REFERENCE: 16/3/3/6/7/1/A5/88/2166/20
DATE: 05/03/2021

COMMENT ON THE PRE-APPLICATION DRAFT BASIC ASSESSMENT REPORT ("BAR") FOR THE PROPOSED EXPANSION OF A DIESEL STORAGE AND DISTRIBUTION DEPOT AT WESGRAAN KLIPHEUWEL SILO ON PORTION 17 OF THE FARM VRYHEID NO. 55, KLIPHEUWEL.

PRE-APPLICATION DRAFT BASIC ASSESSMENT (DBAR) FOR THE PROPOSED EXPANSION OF A DIESEL STORAGE AND DISTRIBUTION DEPOT AT THE WESGRAAN KLIPHEUWEL SILO ON PORTION 17 OF THE FARM VRYHEID NO.55, CAPE FARMS, KLIPHEUWEL

Figure 1: Extract from Site Layout Plan (left) and City of Cape Map Viewer indicating GI1 spot zonings (right).

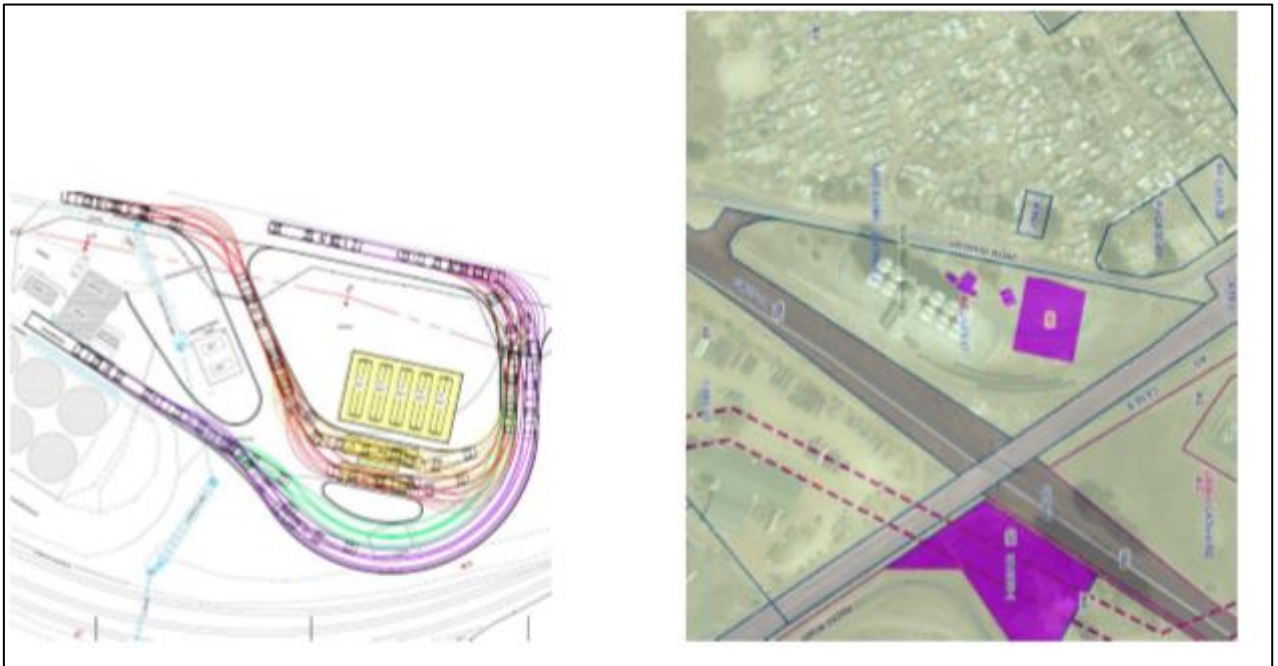
- 1.1 The property is zoned Agricultural Zoning (AG) with spot zonings for General Industrial 1 (GI1).
- 1.2 As per the Site Layout Plan (Option 1; dated September 2020) as compiled by *EFG Engineers (Pty) Ltd*, the existing diesel tanks are evident in close proximity to the silos. It is concluded that the yellow areas marked as T1 to T5 entails the proposed diesel tanks.

- 1.3 This corresponds with the General Industrial 1 zoned area and the filling station per the City of Cape Town land use management zoning and consent use approval (Case ID: 70074044), dated 18 May 2015. The zoning extract included in the documentation (appendix E2) does not include the final notification of the above approval or the conditions of approval referred to in the zoning extract.

Figure 2: Spot zonings on the subject farm as per land use management rezoning and consent use approval (left) and service station as per approved site development plan (right).

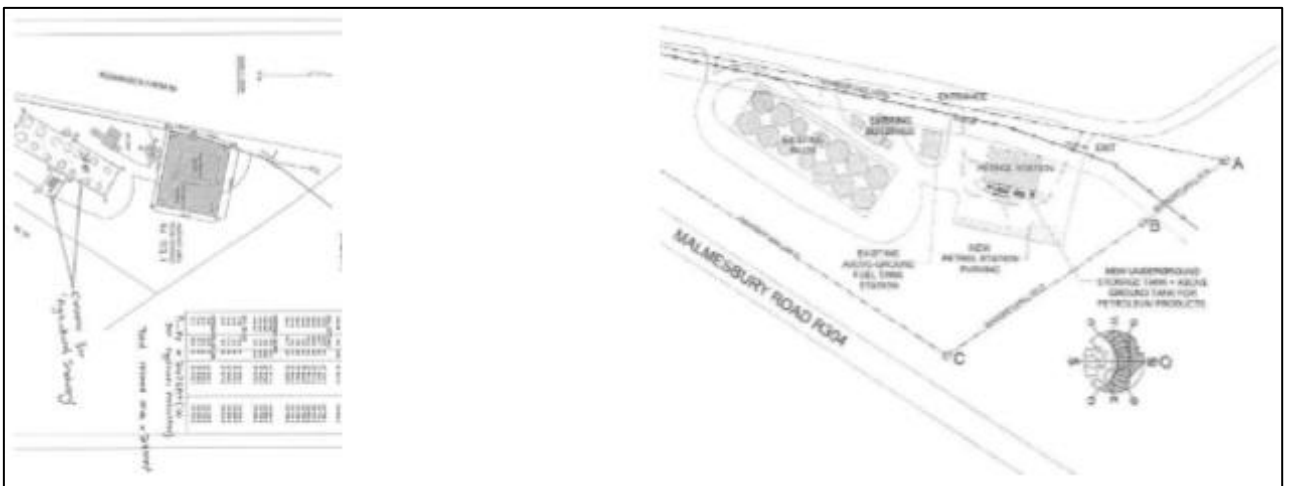
- 1.4 The Fire and Life Safety Department needs to consider the proposal to determine if it entails a Risk Industry. If the latter applies, then a rezoning from GI1 to RI will be required. It is noted however that Fire and Life Safety was satisfied with the proposal and it is therefore, concluded that the proposal will be in terms of the current zoning approval.

Figure 3: Existing Water and Sewer Layout

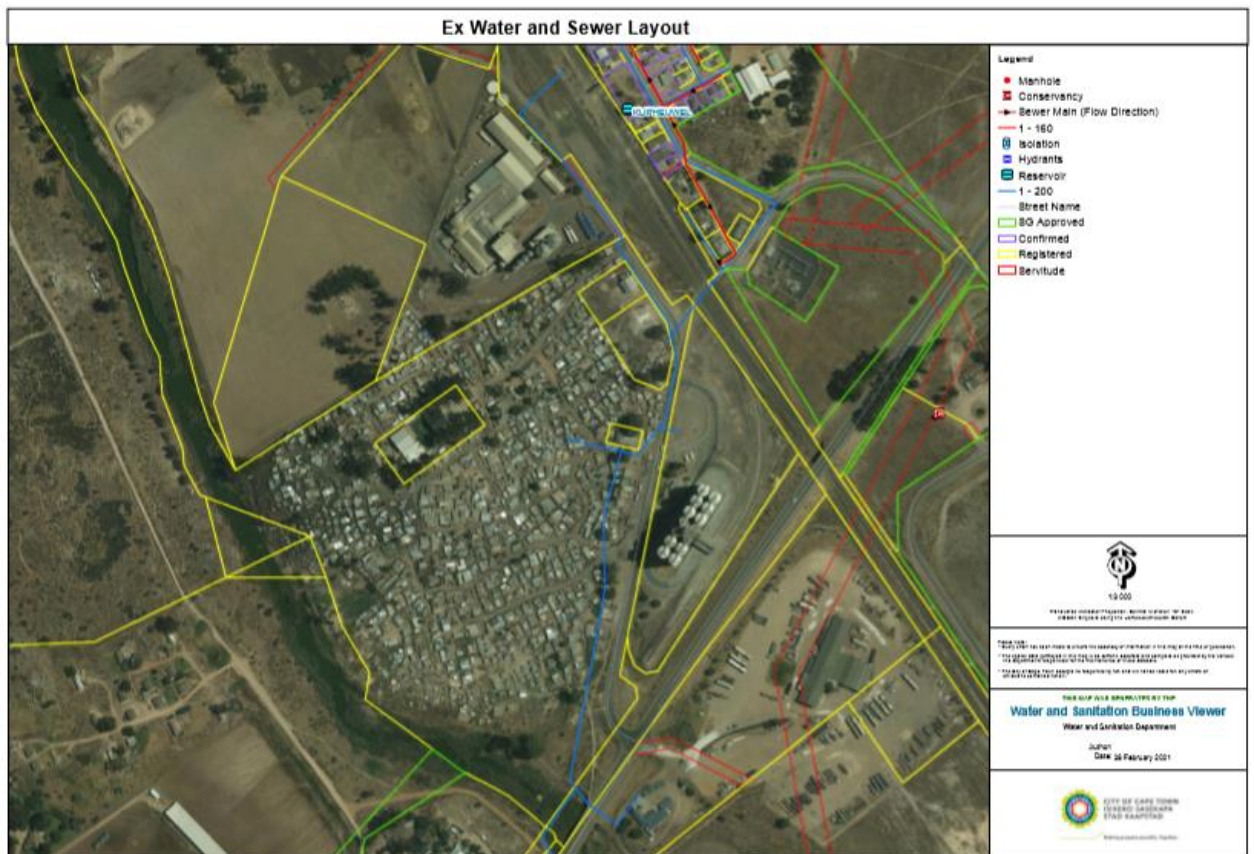
- 9.4 The proposed development falls within the Klipheuwel distribution zone. There is an existing 75mmØ water connection at the north-west entrance, from Vryheid Road, servicing this erf. This connection feeds off a 75mmØ water main serving the informal settlement on the westward of the erf, along Vryheid Road. There appears to be an existing 110mmØ water main at the Northwest vertex of the erf.
